I am writing on behalf of the Center for Energy & Economic Development, Inc., (CEED) regarding the Draft Final Technical Memorandum furnished to MRPO by EC/R, "Reasonable Progress for Class I Areas in the Northern Midwest – Factor Analysis" (July 18, 2007). Please post an electronic copy of these comments on the MRPO website.

Summary of Comments

Figure ES-3. Changes in annual mean PM_{2.5} with EGU1 with IPM candidate control program.

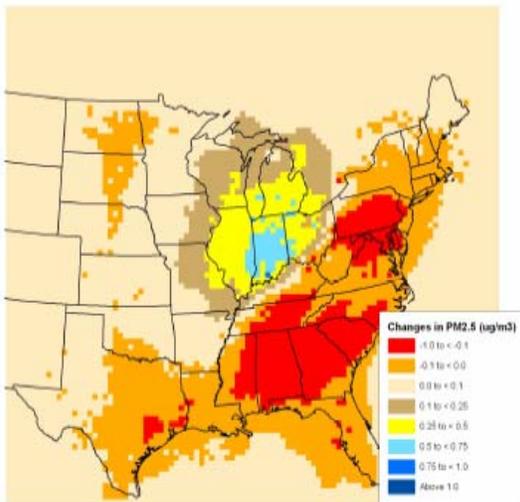
Stratus' health impact findings, summarized in the national IPM cases below, indicate that the potential downwind impacts of emissions "leakage" from the MRPO region largely or wholly offset the benefits of controls imposed within the MRPO. The net benefits of the EGU1 strategy are projected to be negative:

When unrestricted emission trading is permitted, the emission reductions resulting from EGU1 and EGU2 controls within the MRPO region generate tradable allowances that can be sold outside the region. The 2006 Stratus analysis illustrated the effects of such trading in states outside the MPRO region, based on IPM modeling of annual PM_{2.5} concentrations:
